Village at Legacy – Phase II – General Contracting

Addendum No. 1

RFI RESPONSES

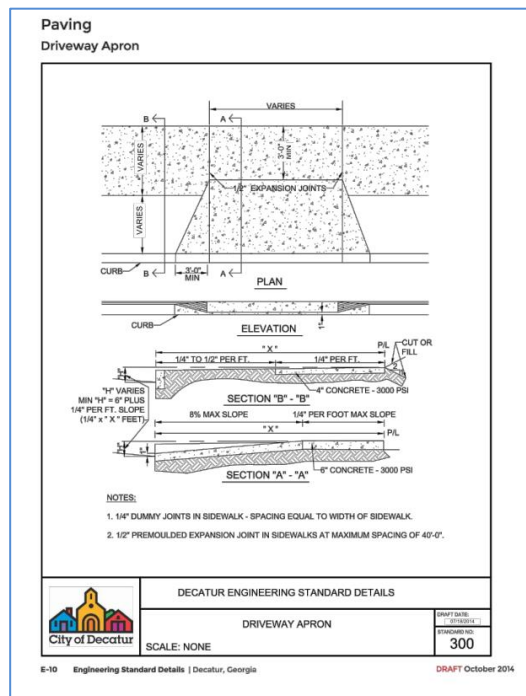
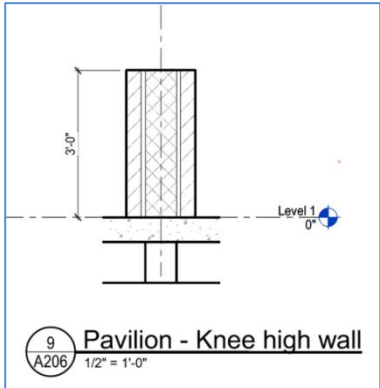
Per Sheet C201 - at entrance to Phase II at tie into Ashbury Drive, there is an unlabeled checkered marking. Please advise/clarify what this marking represents.

The driveway is to be constructed following the detail provided in the construction details pages, heavy duty asphalt up to the sidewalk then concrete as shown in below image.

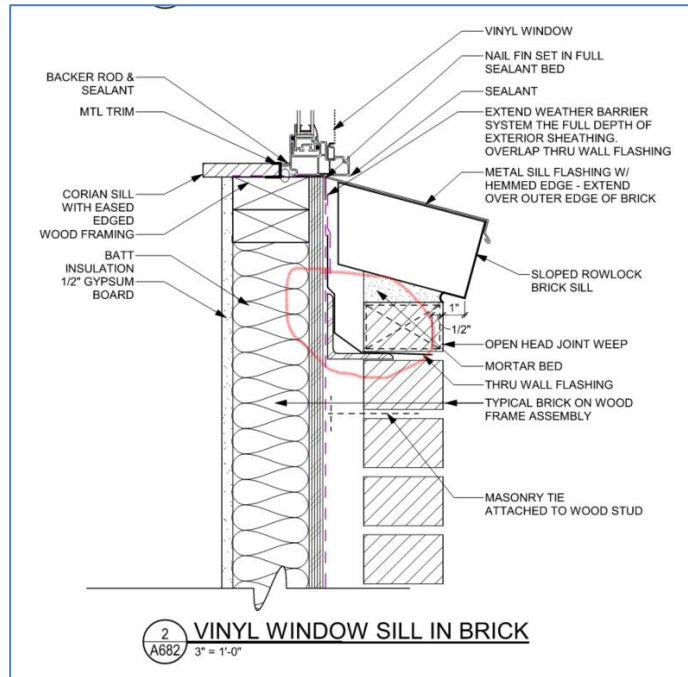
Detail #2 on sheet A682 is showing an un-labeled steel lintel below windowsills. Please confirm this is incorrect.

No steel lintel at the window required as shown in the detail. Relief angles are to be provided per specs.

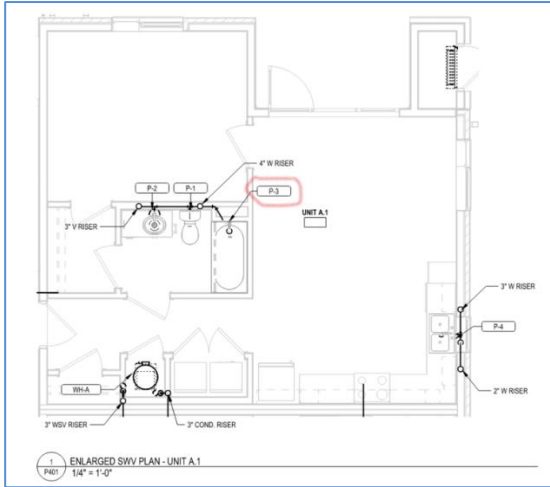
The water heater schedule lists a 40 gal for the capacity but has a 50 gal specification, what is wanted here?

The model number, for a 50 gallon unit, is correct.
